CONSTRUCTION SUMMARY

Forestside Estates Inc.

LOT NUMBER	PHASE	HOUSE TYPE	CLOSING DATE	
148 BLOCK 6	6-III	Blue Ash 2A1	01-Jun-23

Suite: 148

2A1-B.F.

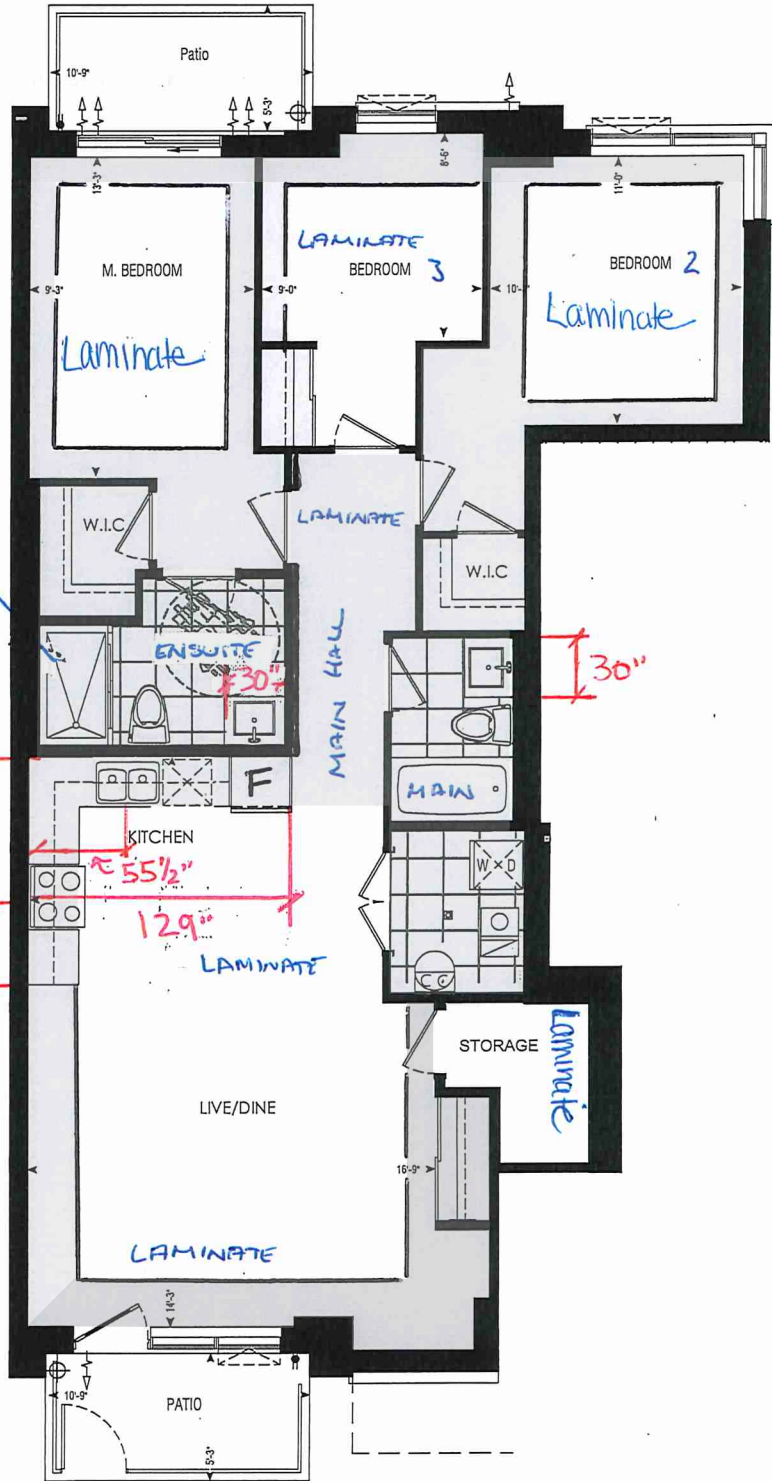
132 - MAIN FLOOR - FLOORING - Install UPGRADE 2 FLOOR TILES (20X20 Pulpis Gris) throughout the main floor where applicable in lieu of the builder's standard floor tiles. To include; Laundry/Mechanical Room, Main Bath, & Master Ensuite.

Note: To be installed straight/stacked (See Sketch)

1 - MASTER BEDROOM - FLOORING - Install UPGRADED LAMINATE throughout the master bedroom where applicable in lieu of the builder's standard broadloom. Install 8" HIGHLAND SUTTON OAK EE-H-289 (See sketch)

1 - BEDROOM 2- FLOORING - Install UPGRADED LAMINATE throughout bedroom 2 where applicable in lieu of the builder's standard broadloom.
Install 8" HIGHLAND SUTTON OAK EE-H-289 (See sketch)
Note: To include Shoe mould

1 - BEDROOM 3 - FLOORING - Install UPGRADED LAMINATE throughout bedroom 3 where applicable in lieu of the builder's standard broadloom. Install 8" HIGHLAND SUTTON OAK EE-H-289 (See sketch)
Note: To include shoe mould

COMMENTS:
BUILDING C SUITE 148 BUK 6

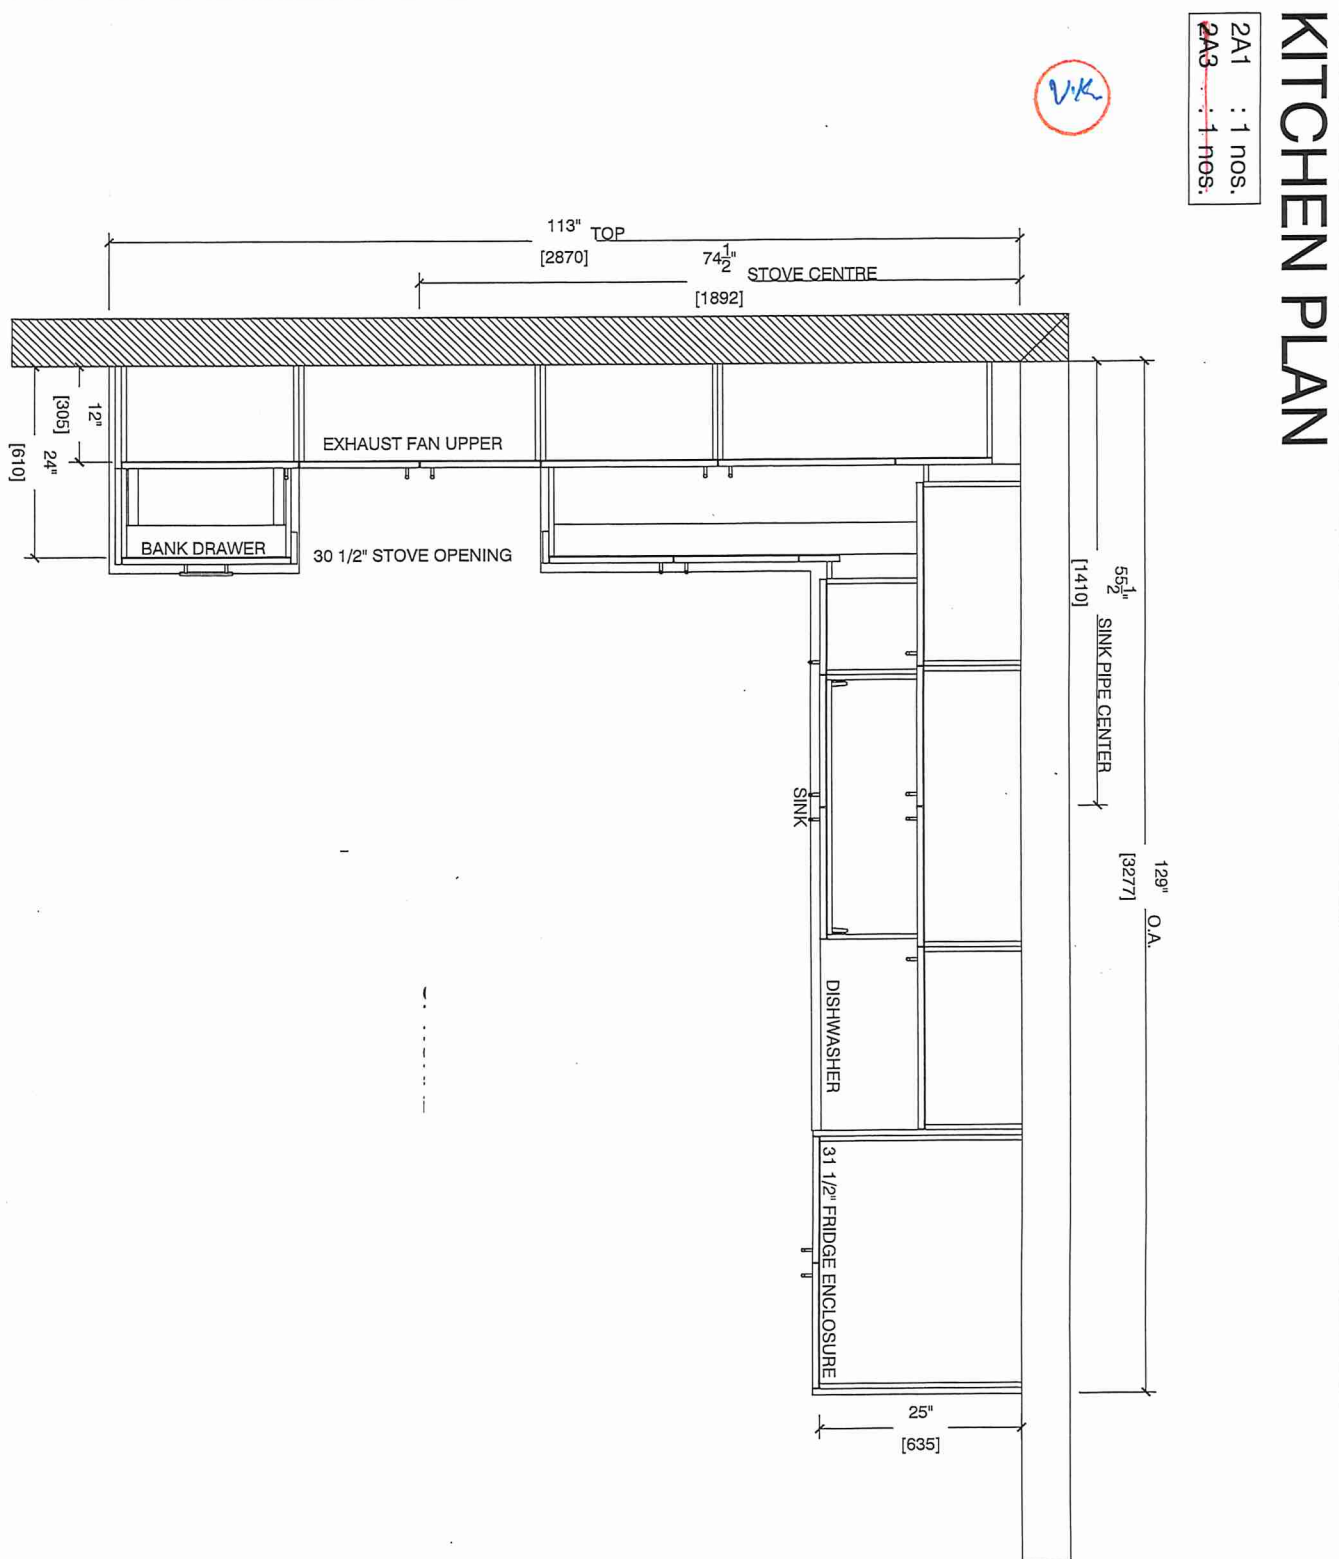
1 - KITCHEN & BATHROOMS - Purchaser has DECLINED All Upgrades offered during decor appointment at the decor centre for kitchen & bathroom cabinetry. Standard Kitchen Layout & Standard Bathroom Vanities to be installed as per standard plan. (See Sketch)

45 - KITCHEN - WALL TILES - Install UPGRADE 1 BACKSPLASH throughout the kitchen in lieu of the builder's standard backsplash. To install TWILIGHT PEWTER/SMOKE. Does not include behind stove/fridge (See Sketch)

1 - KITCHEN - COUNTER - Install UPGRADED "L" EDGE throughout the kitchen where applicable. (see sketch)
